## PALMERSTON NORTH CITY CORPORATION

## BUILDING APPLICATION FORM

I hereby apply for permission to Erect A Dwelling

at 94 Benmore Ave. Palmerston North.

Fig. 68 : Foundation walls supporting masonry veneer

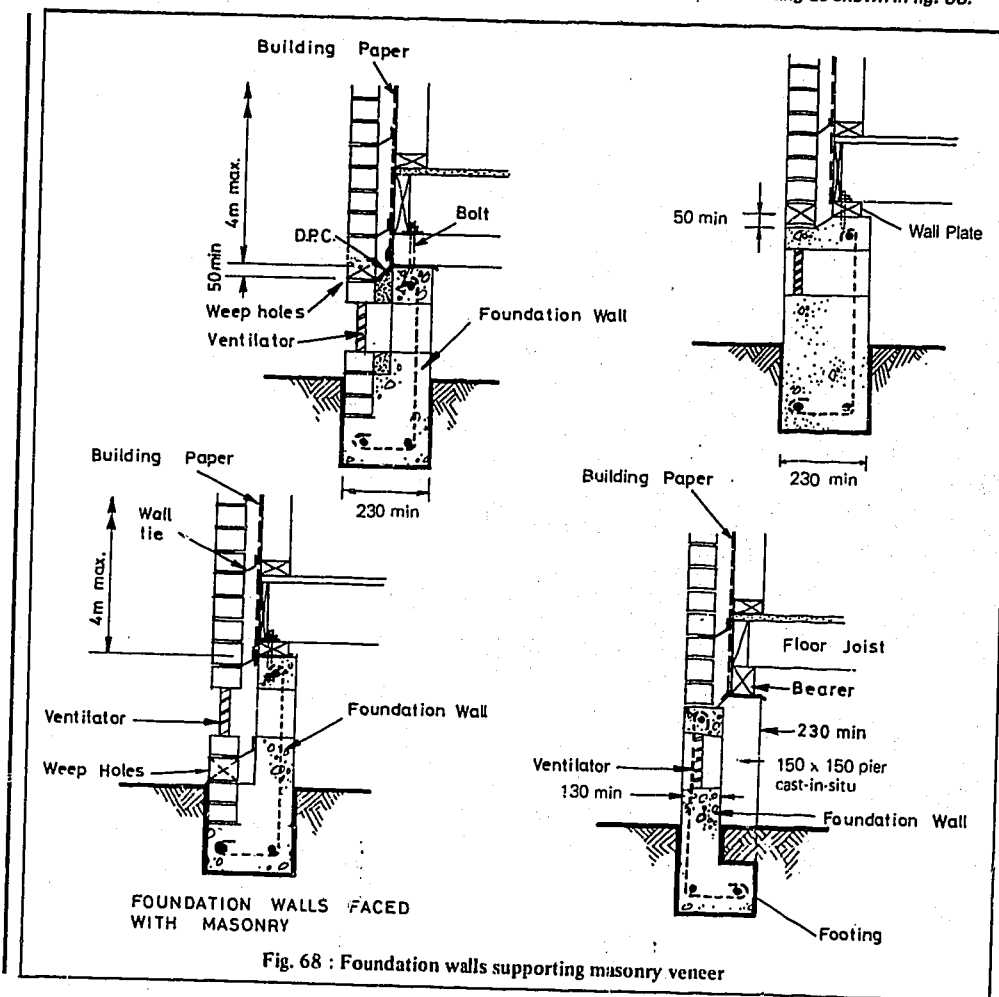
- 22-11-85
1. Brick veneer wall foundations as enclosed 3604 UZ.SS
  2. Foundation ventilation as UZ.SS 3604
  3. If trusses made 'on site' inspection to be made of the first truss.
  4. Metal bracing where shown on the plan.
